**UNITARY PLAN UPDATE REQUEST MEMORANDUM****TO** Warren Maclennan, Manager - Planning North West and Islands**FROM** Cosette Saville, Planner – Planning North West and Islands**DATE** 23 January 2018**SUBJECT** Designation to be updated in the Auckland Unitary Plan  
Operative in Part in accordance with s181(3) of the Resource  
Management Act 1991

## 1426 Westlake Station

**Subject:** Section 176A(2)(c) Outline Plan waiver for the proposed works on the acoustic wall in Designation 1426

D0.31-A

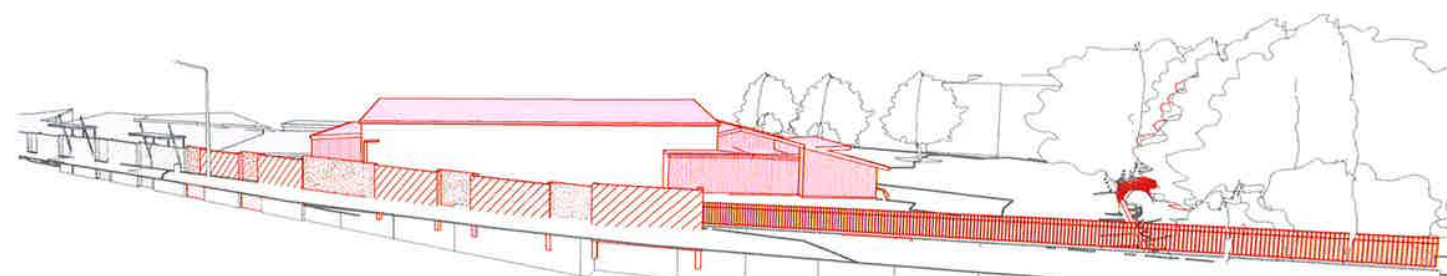
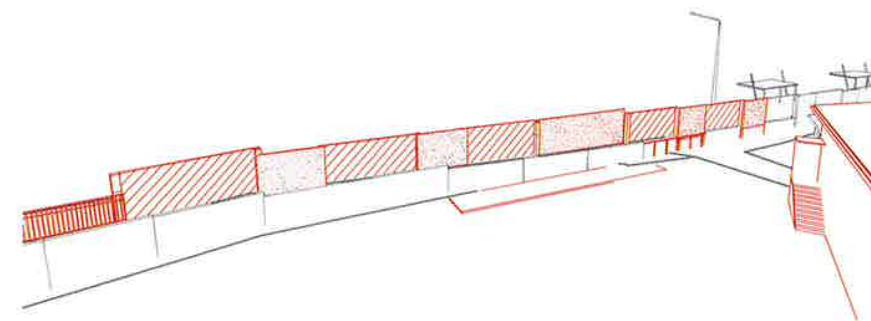
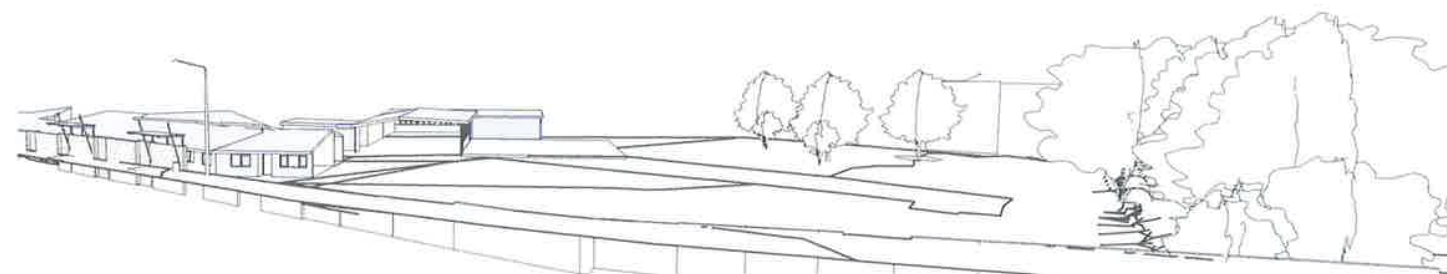
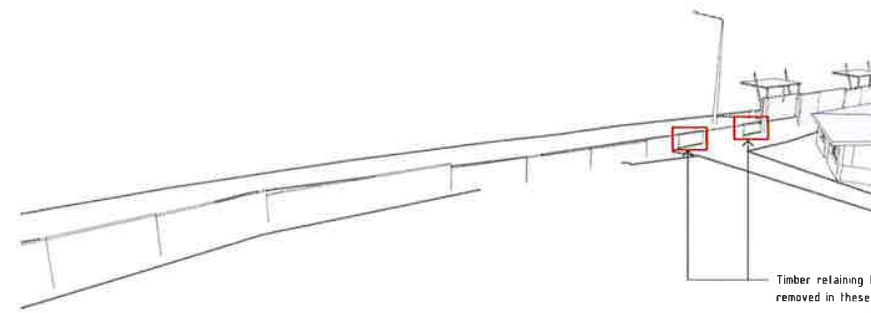
The amendment to Condition 7.1 relates to the alterations which will be made to the existing acoustic wall as a result of the changes which are occurring at Westlake Girls High School. The new Event Centre at Westlake Girls High School has been designed to ensure that the effects of noise from external sources are appropriately mitigated and therefore some 40m of the existing acoustic wall will be removed with 19.5m of the existing acoustic wall being replaced with 1.3m high steel fence. 7m of existing pool fence will also be replaced with new 1.3m high steel fence, and 11.4m of existing pool fence will be removed. The changes are set out in plan SK-035.

The existing 2m high acoustic wall on Shakespeare Road includes small inset landscape bays spaced along the length of the wall. The removal of a total length of some 40m of the acoustic wall in the vicinity of the Westlake Girls High School Event Centre will result in the loss of two existing inset landscape bays, refer to **Figure 6** below. These two particular landscape bays make a very limited contribution to streetscape amenity as the climbers within have made very little growth since their establishment. It is considered that the revised fence/wall design in this location will make a significant improvement to streetscape amenity. The proposed changes will enable views from the street in to the landscaped urban common which is to be created within WGHS, with the new 1.3m high painted steel fence, providing a less dominating street feature, with views available down into the adjoining Event Centre. The reduced thickness of the fence will result in a wider footpath and therefore improved pedestrian amenity. Images of the proposed steel fence are included in Annexure 2. The fence will be painted in a dark colour of similar tone to the existing aggregate concrete noise wall and existing pool fence which is to be retained. The new fence can also be readily cleaned. Consequently, the provision of additional landscaping between the 1.3m acoustic fence and the carriageway is not considered to be necessary in this location.
